Service Information Letter - Fuel Systems

SIL RS-59 Revision 2

RSA-5AD2

SUBJECT: 2576540-4 and 2576540-5 Throttle Friction

Figure 1 RSA-5AD2

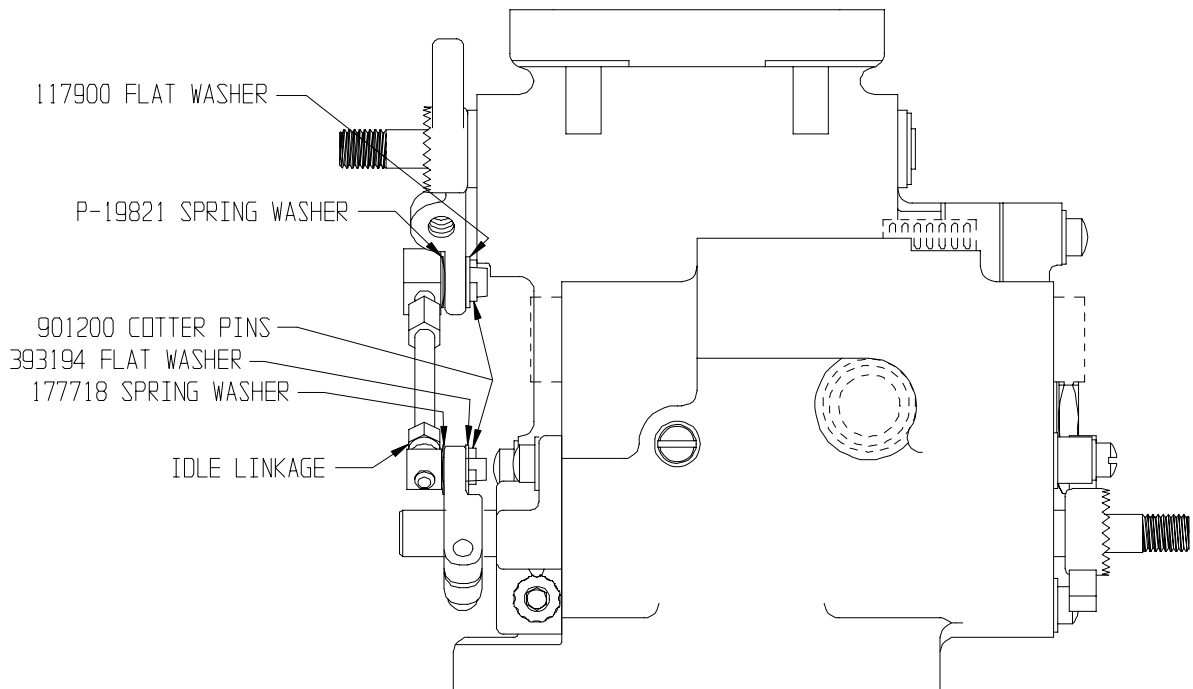
- C. INSPECTION PROCEDURE:** If your aircraft has a 2576540-4 or 2576540-5 fuel injection servo and if the throttle movement is excessively stiff or rough (with the throttle friction off), inspect the idle lever assembly on the RSA-5AD2 fuel control servo for excessive friction. Disconnect the idle mixture linkage at the idle lever arm and throttle arm by removing the cotter pins; be sure to save the flat washers and spring washers for reassembly (see Figure 1). Rotate the idle lever by hand; if the lever action catches, grabs or the force measured directly on the linkage using a linear scale exceeds 4 lbs the servo should be reworked. Insure that measurements are taken perpendicular to the arm of the lever to obtain an accurate reading. The servo should be removed and replaced with a 2576540-7 fuel injection servo.
